CONSTRUCTION SUMMARY OF EXTRAS

Site:INNISFIL

Lot:57W

Model:AVALON 36-08 (A)

Ground Floor
Optional 3 Bedroom Plan
Elevation A

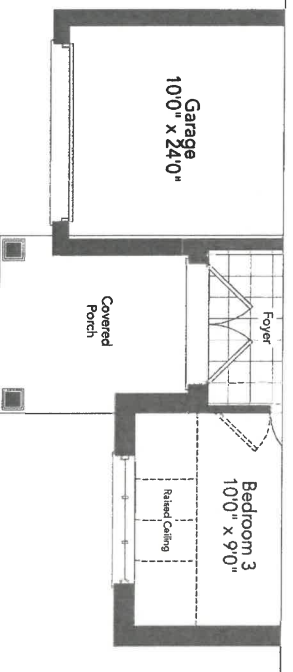
#1	KITCHEN - 7 FOOT PANTRY, 12 INCHES DEEP IN KITCHEN	JUNE 28 2021
#2	KITCHEN - SHIFT ISLAND DOWN APPROXIMATELY 6 INCHES TO LINE UP WITH END OF PANTRY	JUNE 28 2021

#3	N/A	JUNE 28 2021
#4	KITCHEN TWO TONE - ISLAND TO BE A DIFFERENT COLOUR	JUNE 28 2021
#5	KITCHEN SINK - BLANCO SUPER SINGLE 401518	JUNE 28 2021
#6	KITCHEN - POTS AND PANS DRAWER BESIDE STOVE **RELOCATE BANK OF DRAWERS BESIDE FRIDGE	JUNE 28 2021

#7	KITCHEN - WINE RACK IN UPPER CABINETS **SHORTEN ABOVE, CRISS CROSS RACK BELOW	JUNE 28 2021
#8	KITCHEN - ADJUST CABINETS FOR FUTURE OTR	JUNE 28 2021
#9	KITCHEN - MATCHING VALANCE	JUNE 28 2021

#10	KITCHEN - FRIDGE ENCLOSURE WITH GABLE ***NOTE - SIZE OF FRIDGE IS 70-3/16" HIGH ***REQUESTING FRIDGE OPENING TO BE FINISHED AT 71 -1/2" INCHES HIGH AND 37" WIDE	JUNE 28 2021

#26	ELECTRICAL - ADD CAPPED LIGHT CENTRED ABOVE ISLAND ON SEP SWITCH **ISLAND HAS SHIFTED BY 6 INCHES	JUNE 28 2021
#27	ELECTRICAL - BREAKFAST STANDARD LIGHT - SEE FLOOR PLAN FOR DIMENSIONS OF LOCATON	JUNE 28 2021

#28	ELECTRICAL - FAMILY ROOM - ADD (3) CAPPED LIGHT ROUGH INS ON EXISTING SWITCH & MOVE THE STANDARD LIGHT TO CORNER AS PER SKETCH, INSTALL 30 INCHES FROM EACH WALL	JUNE 28 2021

- ① STD BANK OF DRAWERS
- ② ISLAND W/G. 1 - BLACK
- ③ WINE RACK IN UPPERS
- ④ OTR
- ⑤ VARIANCE
- ⑥ FRIDGE enclosure 71 1/2" H X 37" W
- ⑦ LAUNDRY UPPERS
- ⑧ PANTRY 7 FT.
- ⑨ POT DRAWERS

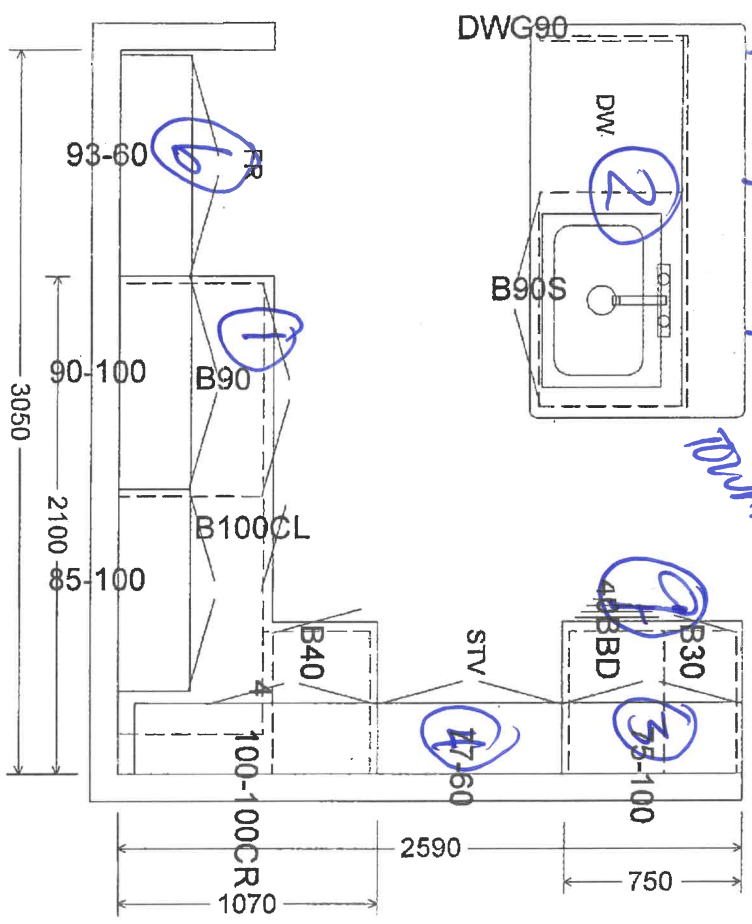
SHIFT DOWN 6" BREAKFAST DRAWERS

OPTIONAL LAUNDRY UPPERS
